UPPER GRANDE RONDE RIVER SUB-BASIN

**TOTAL MAXIMUM DAILY LOAD (TMDL)
& WATER QUALITY MANAGEMENT PLAN (WQMP)**

Response to Public Comment

*Oregon Department of Environmental Quality
April, 2000*

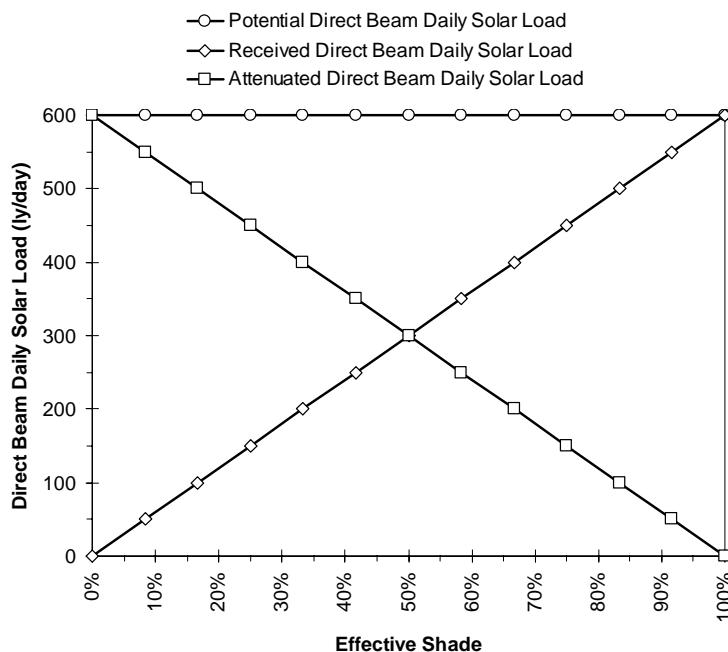
4. Question: What does “serve as a linear translator” mean [in reference to the use of shade as a surrogate for solar loading, page 19]?

Answer: Effective shade is the percent of the daily direct beam potential solar load that is attenuated before reaching the stream.

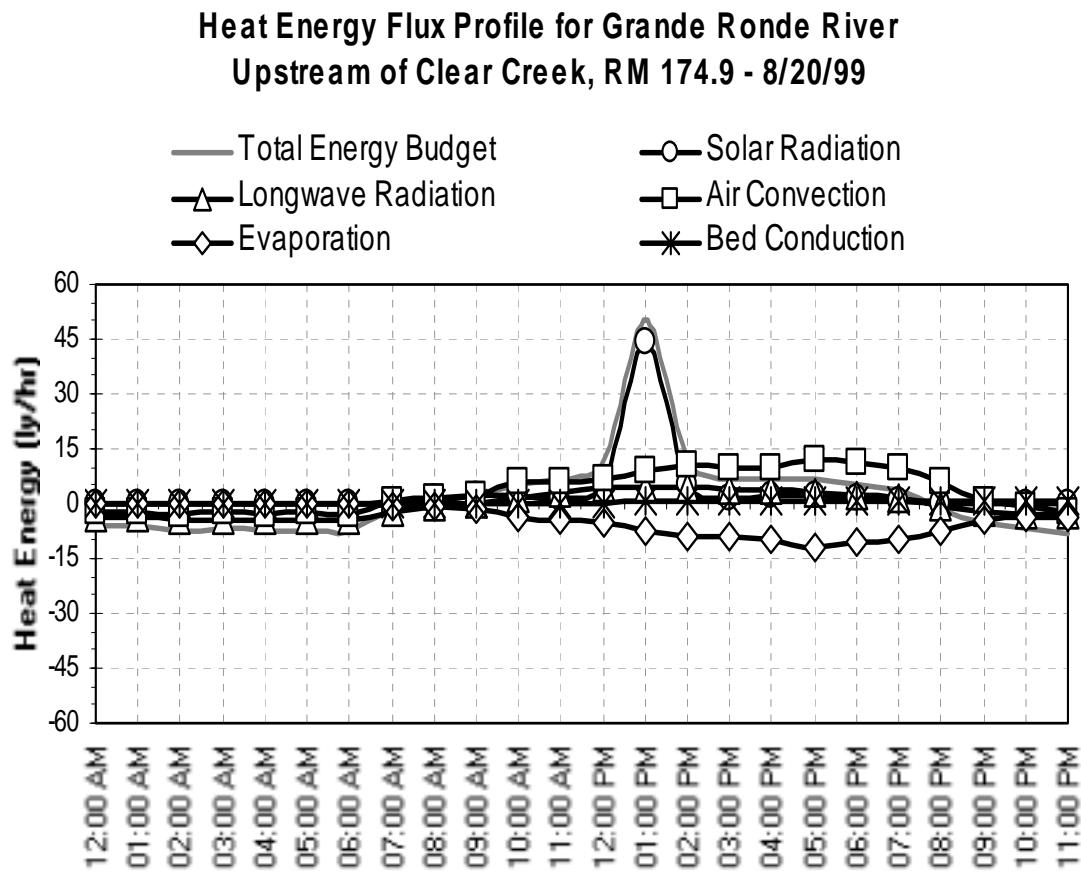
40. Questions relating to the definition of temperature. The questioner eludes to statements made in the TMDL documents relevant to temperature: On page A-74, water temperature is a function of the total heat energy contained in a discrete volume and may be described in terms of energy per unit volume. And on page 15, water temperature is an expression of heat energy per unit volume. The questioner then argues that this is an inappropriate definition of the word temperature and follows with two questions: How does ODEQ explain (and/or justify) their definition of temperature? To what extent does ODEQ recommend that the rest of the TMDL be trusted if it is based on this definition of temperature?

Answer: The questions and premises set up here imply that DEQ has used the wrong definition of temperature and then attempt to discredit the entire TMDL because of that definition. One does not follow from the other. First of all, DEQ does not define temperature. DEQ states that water temperature is a function of the amount of heat energy contained in a discrete volume. This is a true statement that is not disproved by the discussion of the definition of temperature. Second, regardless of the definition of temperature, one cannot legitimately call into question the entire TMDL, the loading capacity and the allocations developed in the TMDL, on the basis of the definition of temperature. The TMDL is not dependent on the questioner's definition of temperature.

Heat Energy Flux Profile for Grande Ronde River Grande Ronde Valley, Pierce Lane - 8/20/99

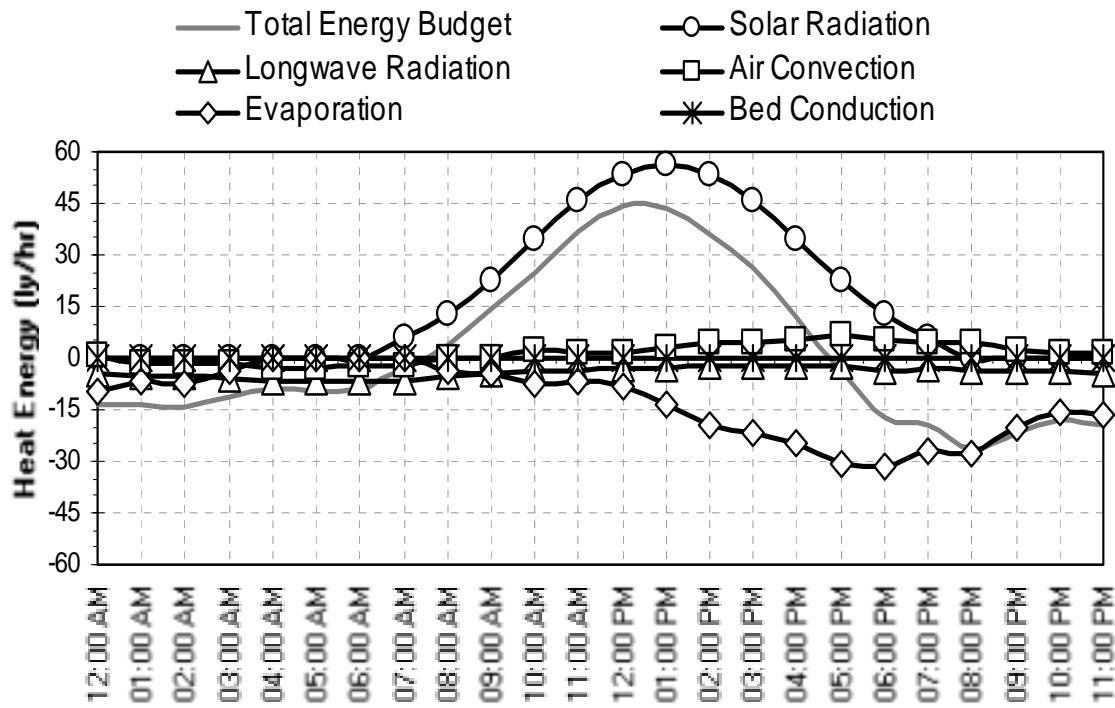
41. Questions related to heat energy continuity. After several pages of discussion of equations from the TMDL related to heat energy continuity one commenter posed a number of related questions.

1. No. Thermodynamic components are variable in time and space.
2. All thermodynamic components are calculated every 60 seconds over the simulation period at 100 feet (30.5 meters) spatial intervals. For example, the solar angle is calculated every 60 seconds in the simulation period and every for all 100 feet length interval.
3. As mentioned in Answer #2, all thermodynamic components are calculated every 60 seconds over the simulation period at 100 feet (30.5 meters) spatial intervals. Energy components differ greatly in both temporally and spatially as demonstrated in these graphs.

4. Answers #1 - #3 clearly explain that thermodynamic components are a function of time and space. Further, The units of the energy flux components are ly/time (i.e. heat energy per surface area per time). Since the units correspond to space and time, it should be clear that both are considered in the methodology.
5. The thermodynamic components are updated with respect to time (every 60 seconds) and space (every 100 feet) in the finite difference methodology.
6. The finite difference solution is utilized to update thermodynamic components that are functions of stream and air temperatures (i.e. convection, evaporation and longwave radiation and bed conduction). Specifically, stream temperature profile from the previous time step (i.e. 60 seconds prior) is used to supply stream temperature information for every distance step (i.e. every 100 feet).
